SUB: Groundwater Monitoring Program Optimization Plan  
Sludge Lagoon Closure and Post Closure Monitoring Plan  
Grenada Manufacturing, LLC / EPA ID No. MSD007037278

Subject: Solid Waste Management Unit 4 – Sludge Lagoon  
Closure and Post-Closure Care Plan  
Grenada, Mississippi

**SOILD WASTE MANAGEMENT UNIT 4 – SLUDGE LAGOON  
CLOSURE AND POST-CLOSURE CARE PLAN  
DECEMBER 2008 REVISION INSTRUCTION SHEET**

FIGURE 2-1  
PROPOSED FINAL COVER SYSTEM

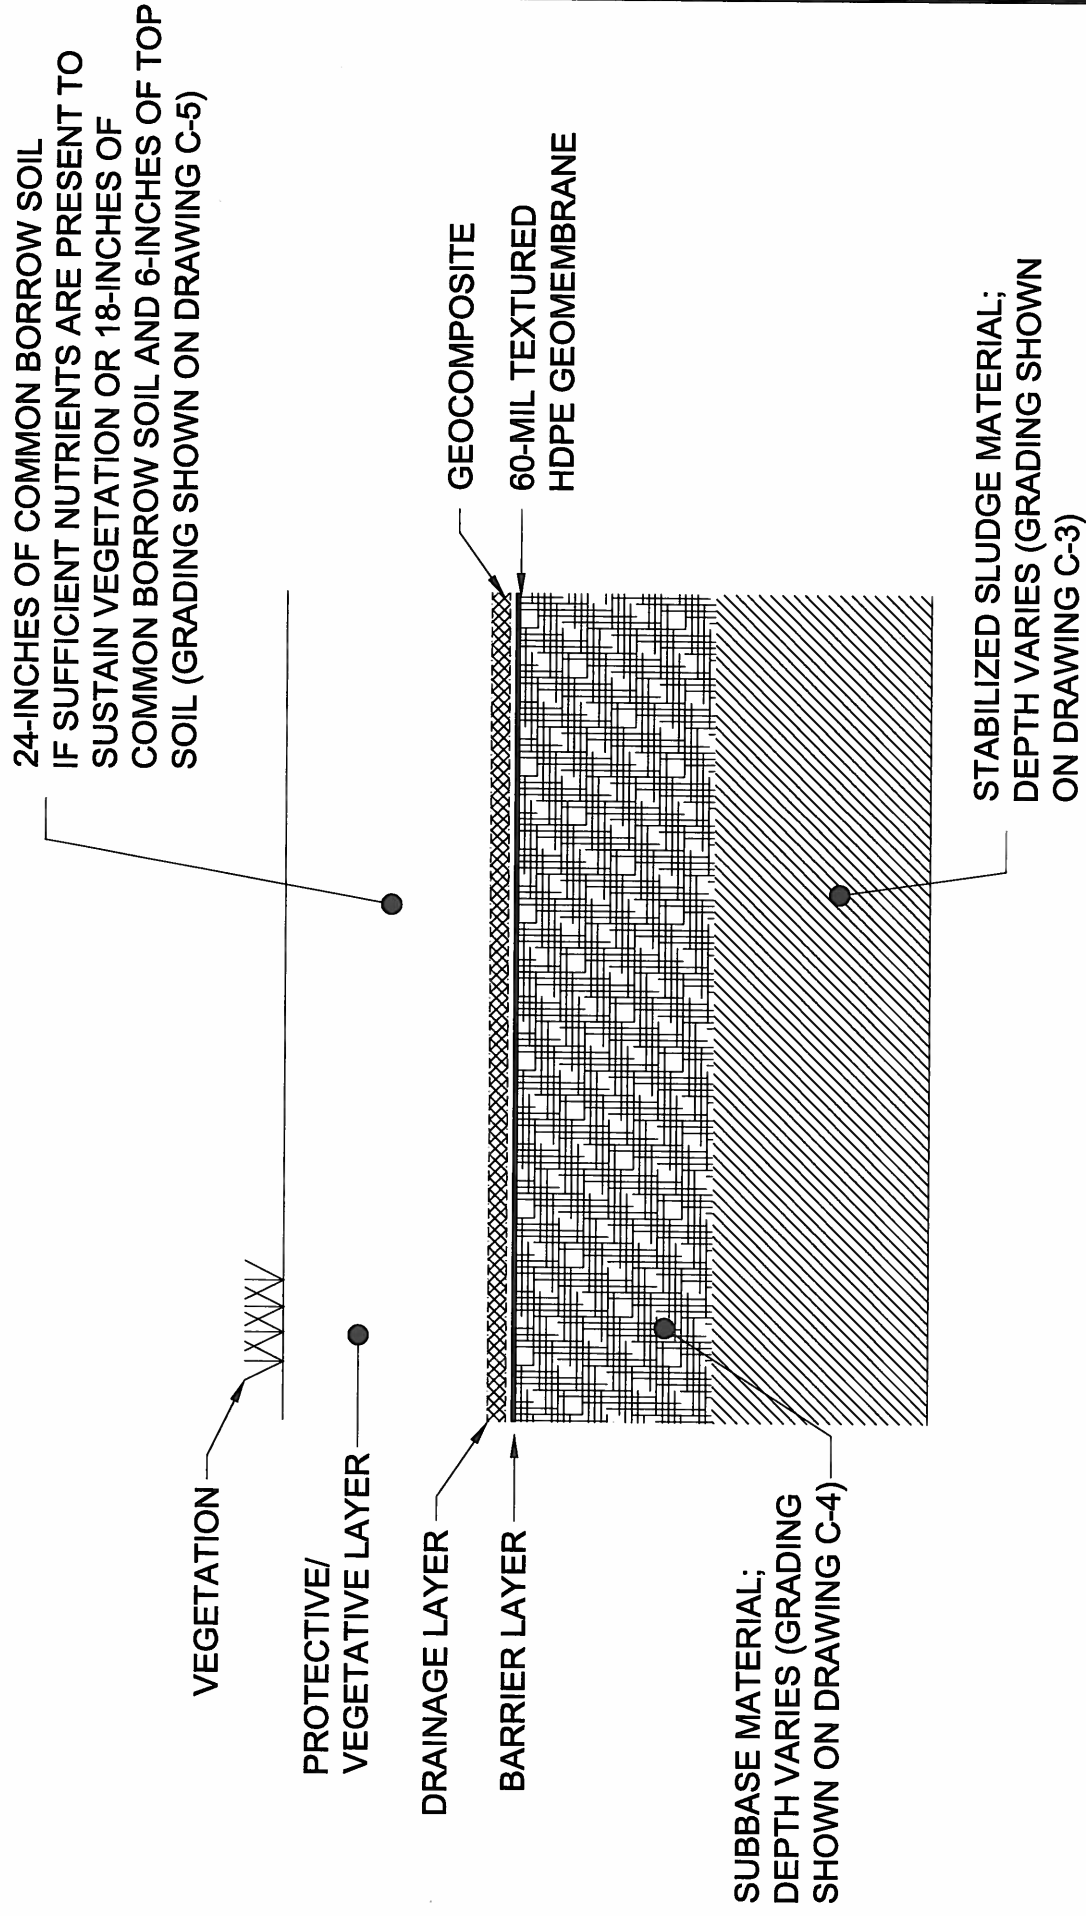
The revisions were prepared to respond to a comment the Mississippi Department of Environmental Quality (MDEQ) had with the composition of materials to be used in the final cover system. The subbase material that will be constructed on top of the solidified/stabilized sludge material and upon which the geomembrane of the final cover system will be constructed was inadvertently entered into the HELP Model as possessing a "soil texture" of 5 instead of 11. The effect of using soil texture 11 instead of soil texture 5 is the permeability value of  $6.4 \times 10^{-5}$  centimeters per second (cm/sec) versus  $1.0 \times 10^{-3}$  cm/sec, respectively. The  $6.4 \times 10^{-5}$  cm/sec value for the permeability more closely reflects the permeability of the silty clay soil materials present at the Site based on information obtained from soil borings and geotechnical test results from the "Soil and Foundation Investigation, Wastewater Treatment Facilities, Rockwell International, Grenada, Mississippi" report dated June 12, 1975 prepared by Ware Lind Engineers, Inc. of Jackson, Mississippi.

The HELP Model was revised using soil texture 11 and the permeability value of  $6.4 \times 10^{-5}$  cm/sec for the subbase material. The results of the revised HELP Model provide the same conclusions as previously presented; the final cover system as proposed is effective in minimizing both the amount of surface water infiltration into the subbase and ultimately the solidified/stabilized sludge material and the maximum head of infiltrated surface water on top of the geomembrane. The revised HELP Model is provided as part of the Plan revisions.

Remove the existing Figure 2-1 Final Cover System Configuration page 2-8 and replace with revised Figure 2-1 Final Cover System Configuration page 2-8.
